As I will not be available to attend today's meeting, I'd like to share with you and the Commissioners my comments on the suggested changes to the TOD-1 zoning district. I have attached my responses to the presentation deck presented at the MSTeams public meeting on 3/14, but wanted to highlight a few things:

Zoning Changes: TOD-1 & Stadium District Signage Overlay

Comments/Suggestions: Mark A. Olinger
Rev. 3.19.23

- Stadium District Signage Overlay
- Priority street
- - Street-oriented commercial

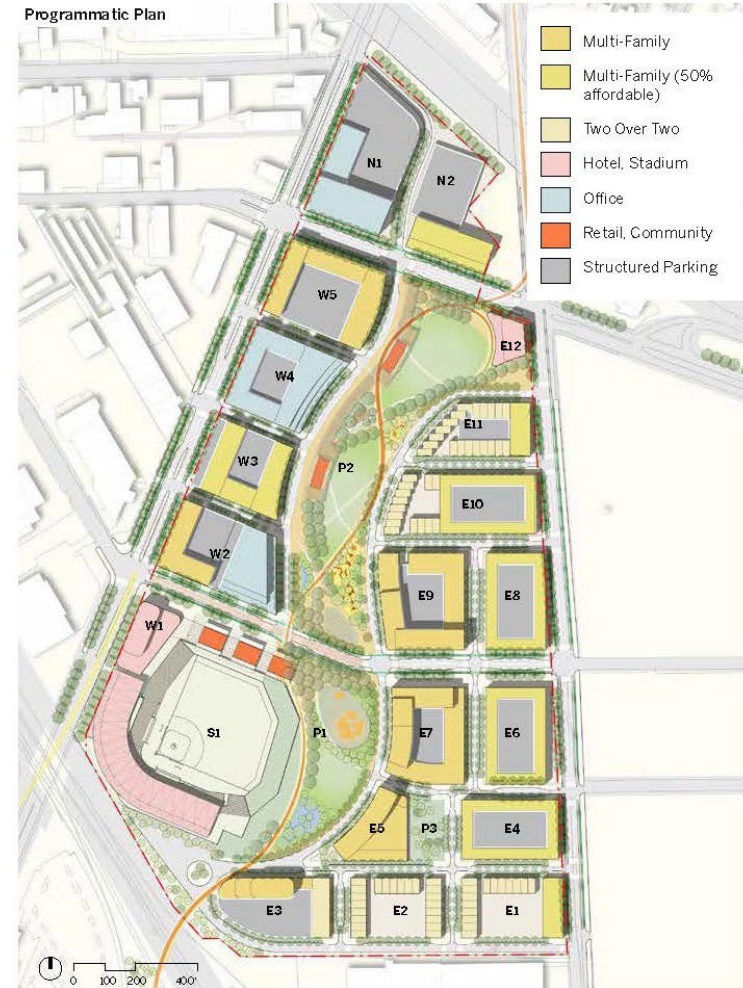
* The size doesn't bother me as much as the tendency, once a building is designed, to put signage on its face. They should have “signable areas that don't impinge on architectural detail, windows, etc. Creativity, but with intent and coherence

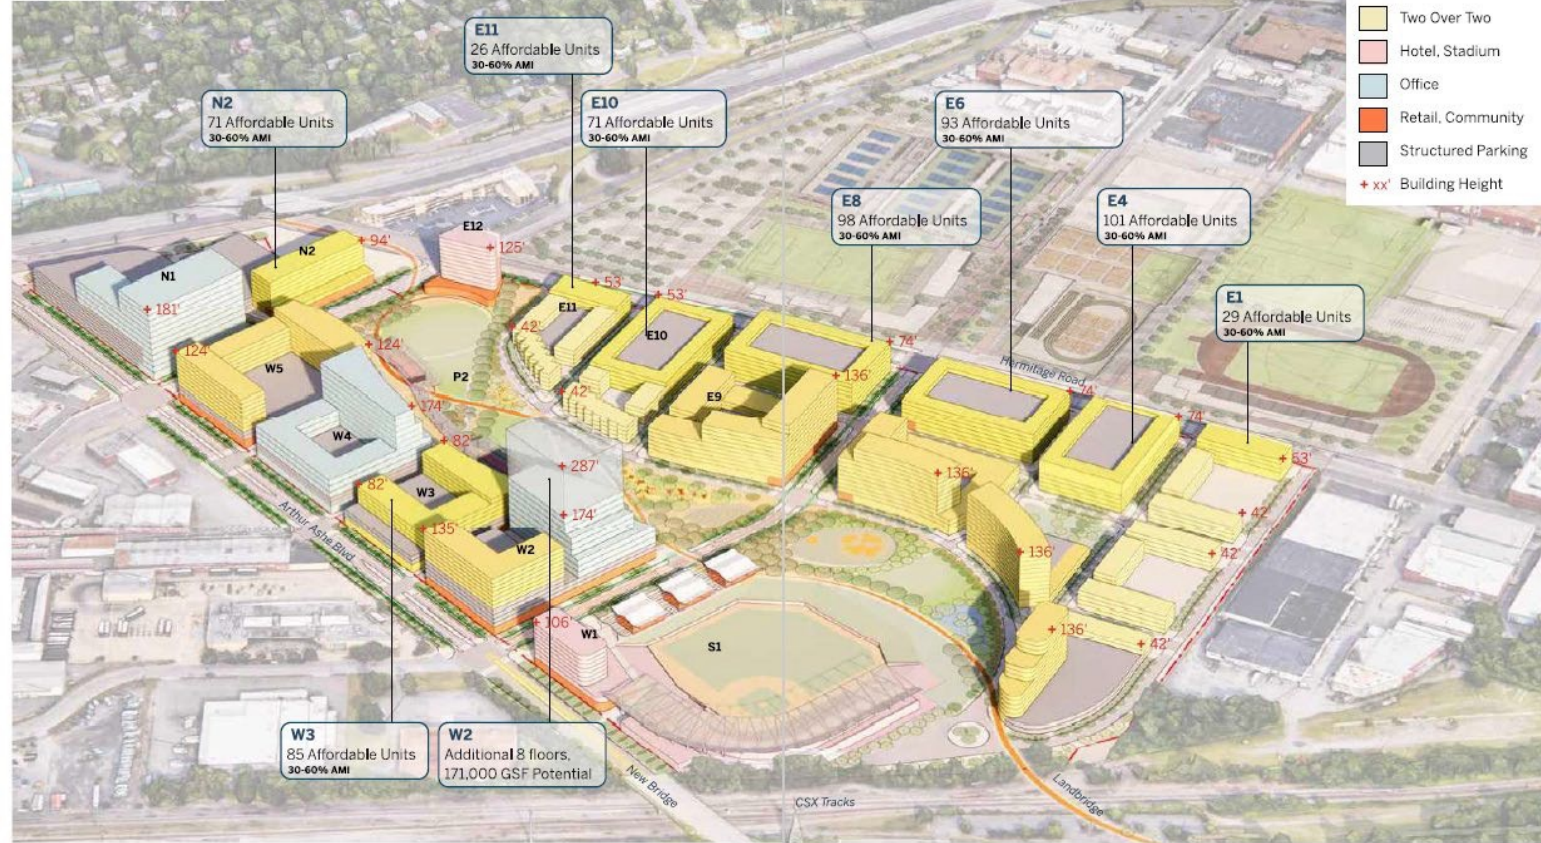
* **No real issue here**
